ILLINOIS POWER COMPANY

CLINTON POWER STATION, P.O. BOX 678, CLINTON, ILLINOIS 61727

Subject: Additional Information Regarding Clinton Power
Station Proposed License Amendment to Support
Hydrogen Water Chemistry Testing

PLANT DEVELOPMENT
 CLINTON POWER STATION #1
 UNIT 1
 ILLINOIS POWER COMPANY
 CLINTON, ILLINOIS

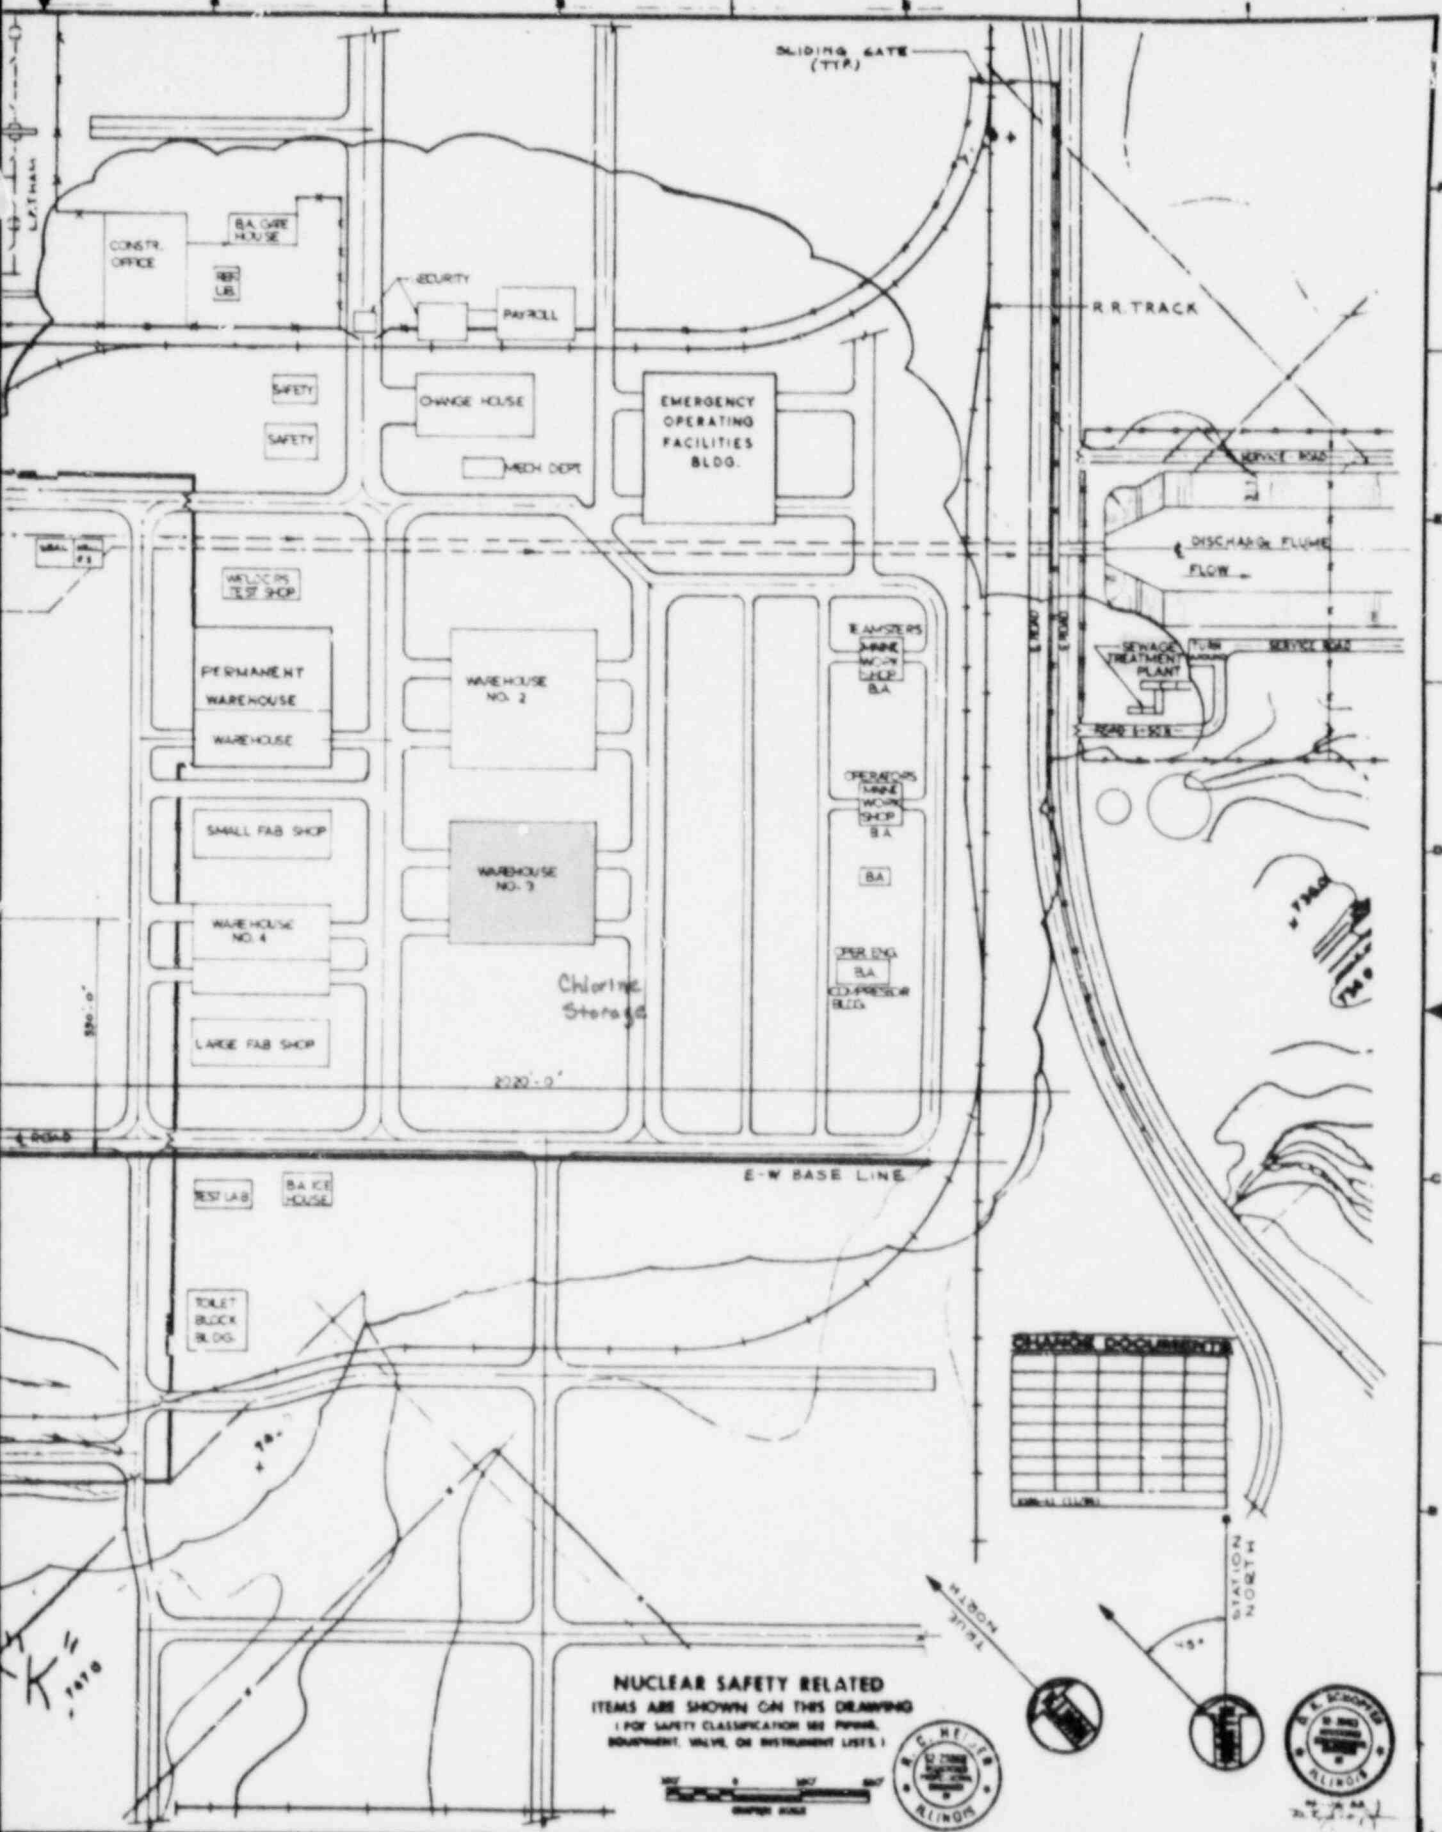
Provide a description of the on-site storage of chlorine, used for water treatment, indicating the separation distance between the hydrogen and chlorine and the pathway for truck related delivery at the site.

Currently, chlorine is used in the makeup water pump house and sewage treatment plant. The chlorine at these facilities is stored in 150-pound containers. Additional 150-pound chlorine containers are stored near warehouse No. 3 (see attached drawing). The existing hydrogen storage is approximately 475 feet away from the makeup water pump house, 600 feet away from the warehouse No. 3 and 1000 feet away from the sewage treatment plant. The attached drawing shows the location of these structures and the path the hydrogen tube trailer will take when being delivered. It should be noted that delivery of hydrogen for the HWC test will be consistent with the current methods of hydrogen delivery.
